**RE: Sigma-Aldrich (Sigma) Fort Mims Site, Documents relating to NRC's Request  
for Additional Information, USNRC License # 24-16273-01**

**RE: Sigma-Aldrich (Sigma) Fort Mims Site Decommissioning, Request for Additional Information, USNRC License # 24-16273-01**

### **Additional RESRAD Modeling and Uncertainty analyses**

**Dose from All Pathways v.s. Hydraulic Conductivity of  
Unsaturated zone 1**

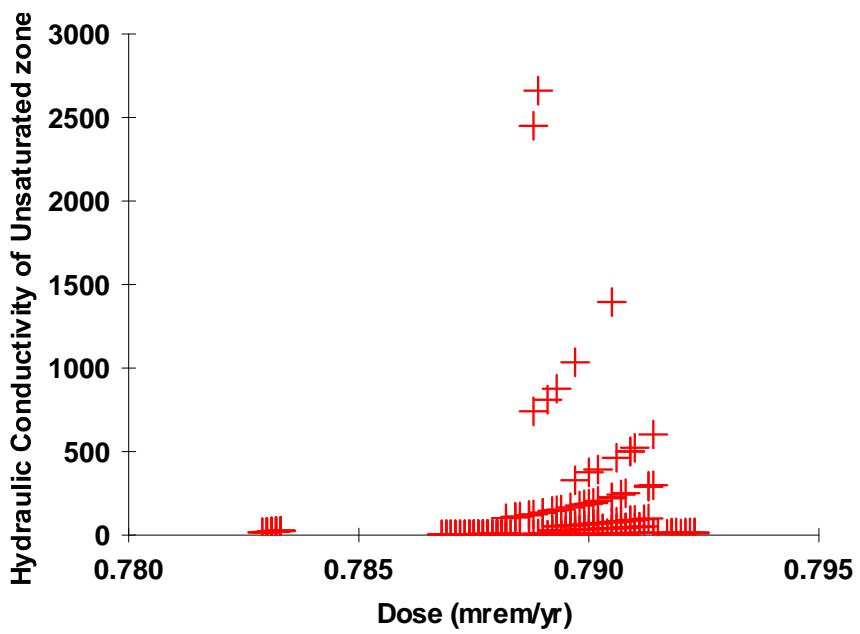
**(2) Provide uncertainty analysis for site-specific parameters, including the distribution coefficient and hydraulic conductivity, to demonstrate that uncertainty in the model geological parameters will not result in a significant increase in exposure. If significant increase in exposure is found in the uncertainty ranges of these parameters, further justification may be required for site-specific information.**

Uncertainty analyses are also provided in the Philotechnics report (Attachment 4). The report documents additional uncertainty analyses on hydraulic conductivity (Ksat) and distribution coefficient (Kd). A total of FIVE analyses were run:

None of the models indicated any appreciable difference in dose.
